***JAPAN's Comments on
Backset Requirements of
FMVSS 202aS
Final Rule***

GRSP INFORMAL WORKING GROUP ON HEAD RESTRAINTS

JAPAN MLIT

(2) Results of determining variations

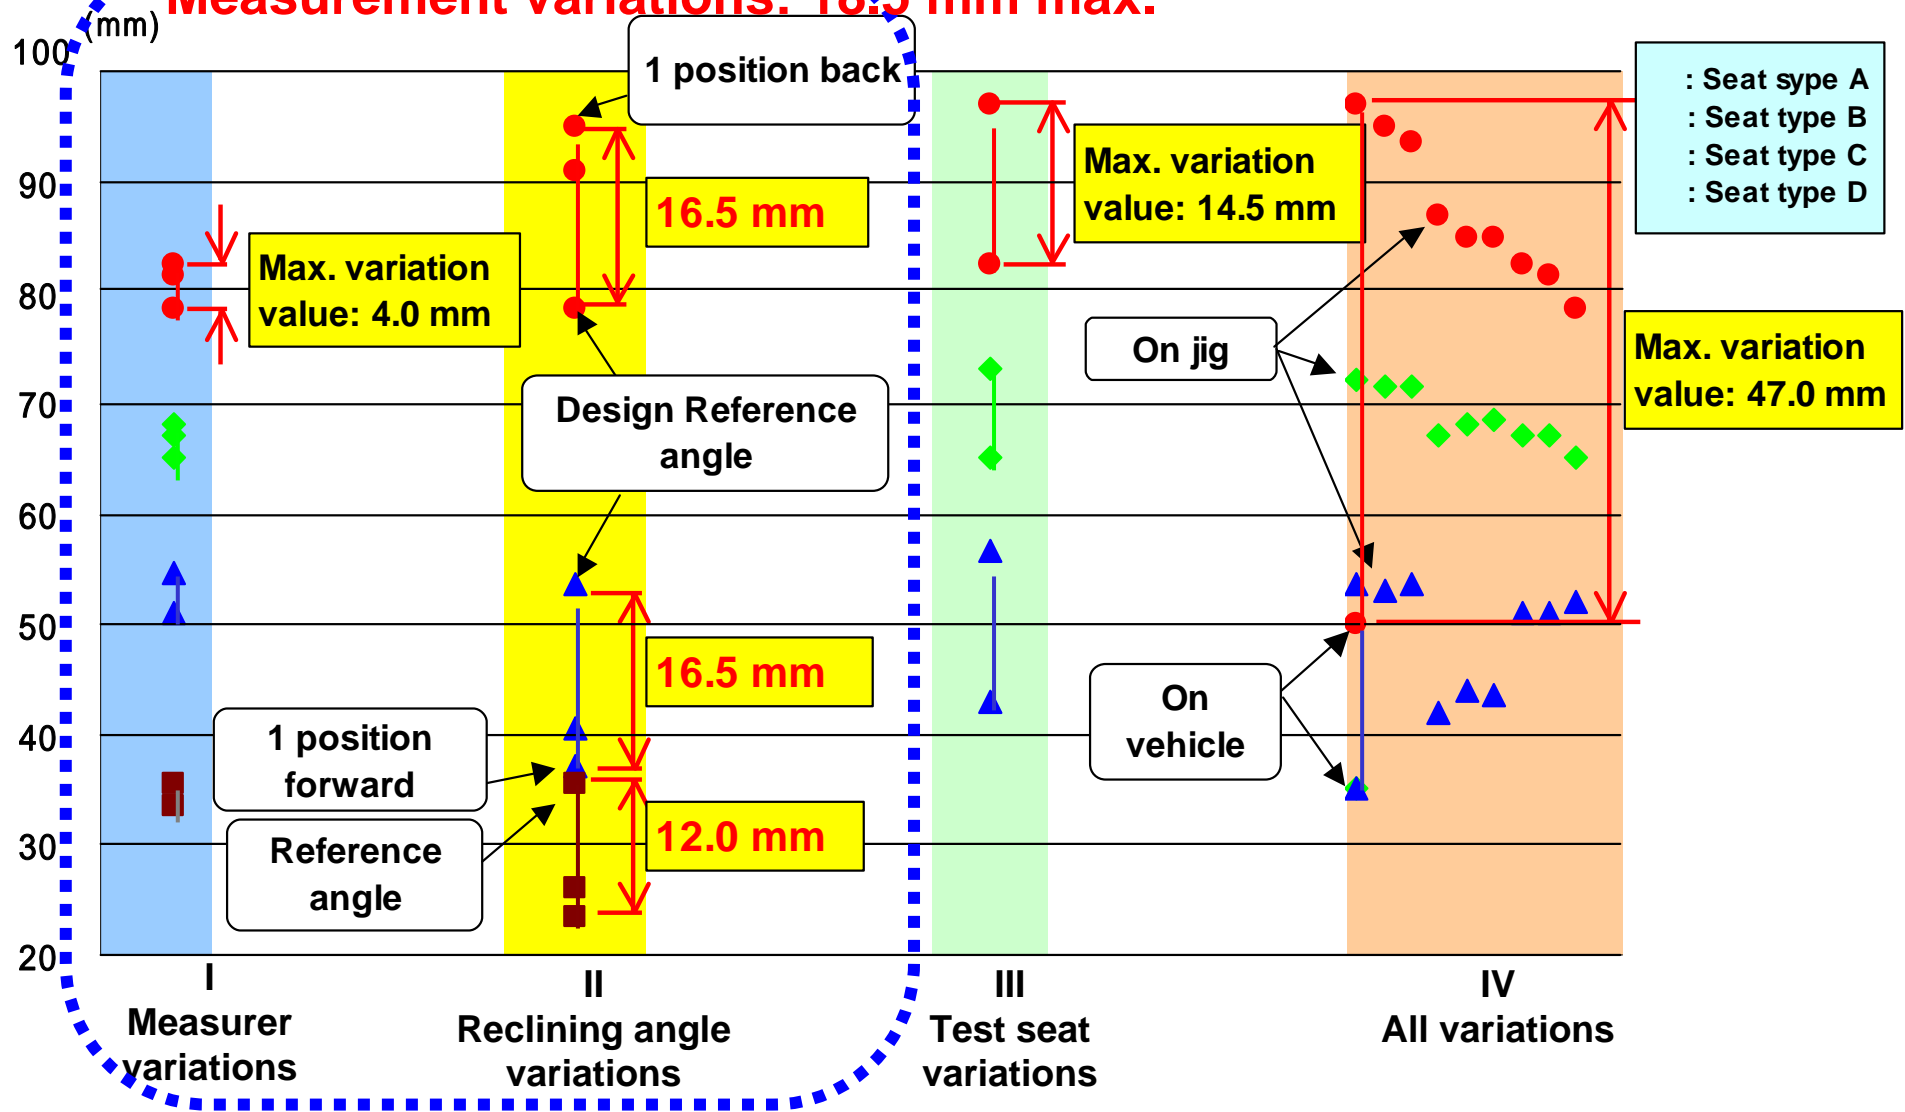
Measurement variations: 18.5 mm max.

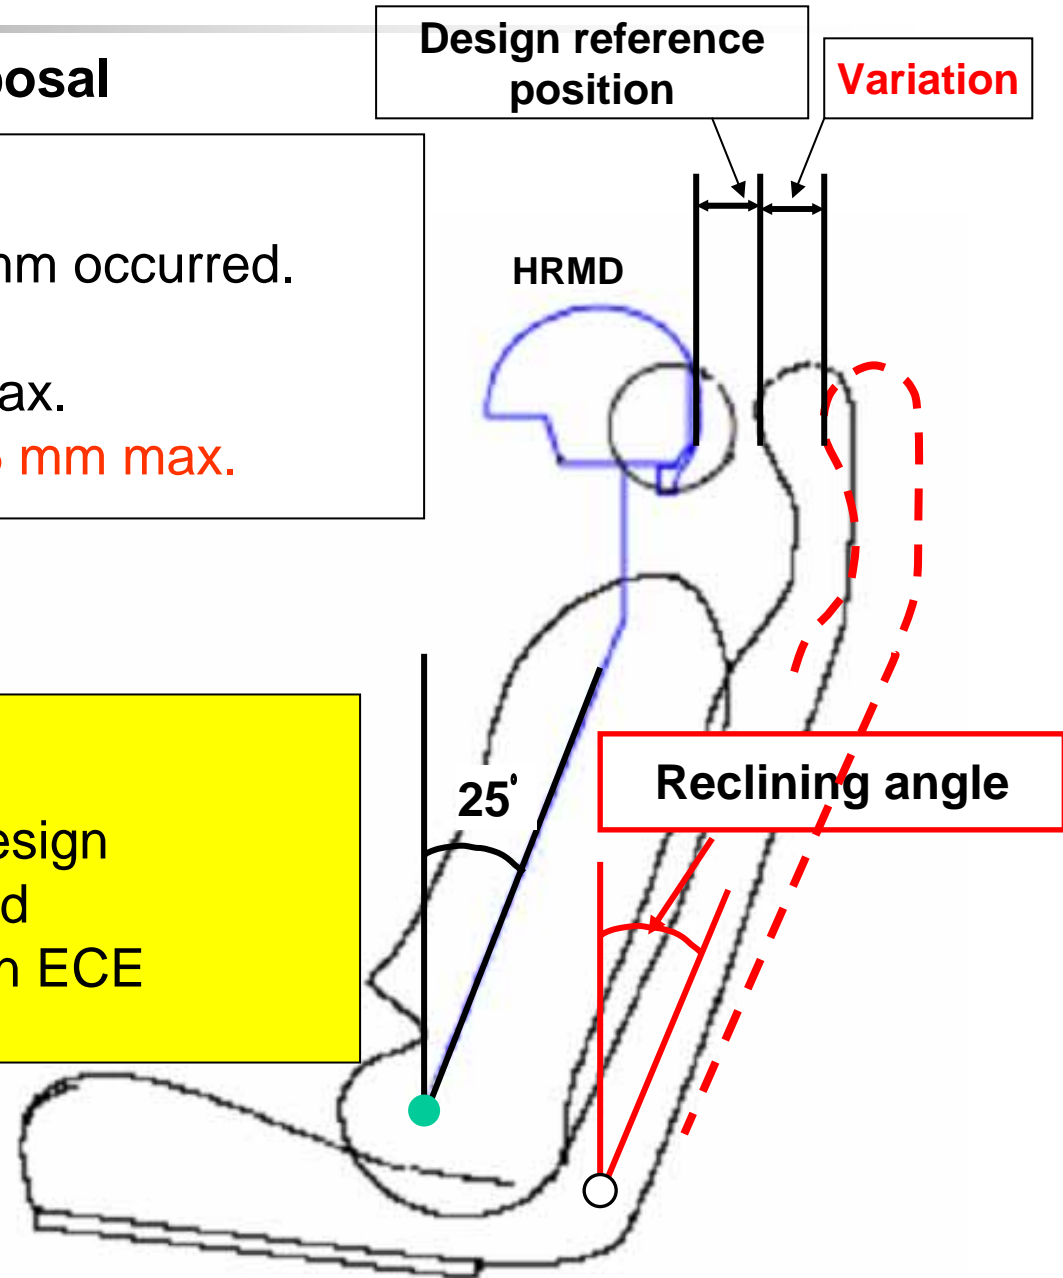
A maximum variation of 18.5 mm occurred.

- Measurers variation: 4.0 mm max.
- **Reclining angles variation: 16.5 mm max.**

To measure backset at the design reference position (with a fixed reclining angle) as specified in ECE

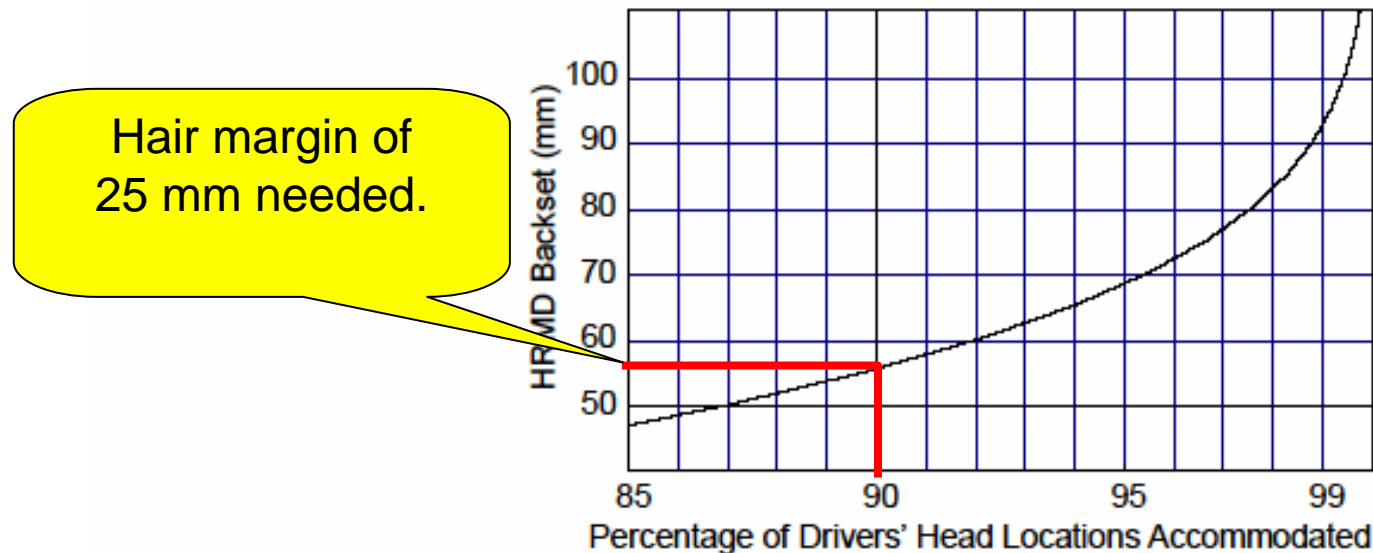
(2) Regarding the figure referenced by NHTSA (shown below), UMTRI clearly states that a **hair margin of 25 mm** is needed.

If head restraints complying with the NPRM were added to current driver seats, the head restraints would interfere with about 13 percent of drivers preferred head positions. The head restraints would contact the hair of about 33 percent of drivers, assuming a median hair margin at the back of the head of 25 mm. Figure 3 shows the percentage of drivers
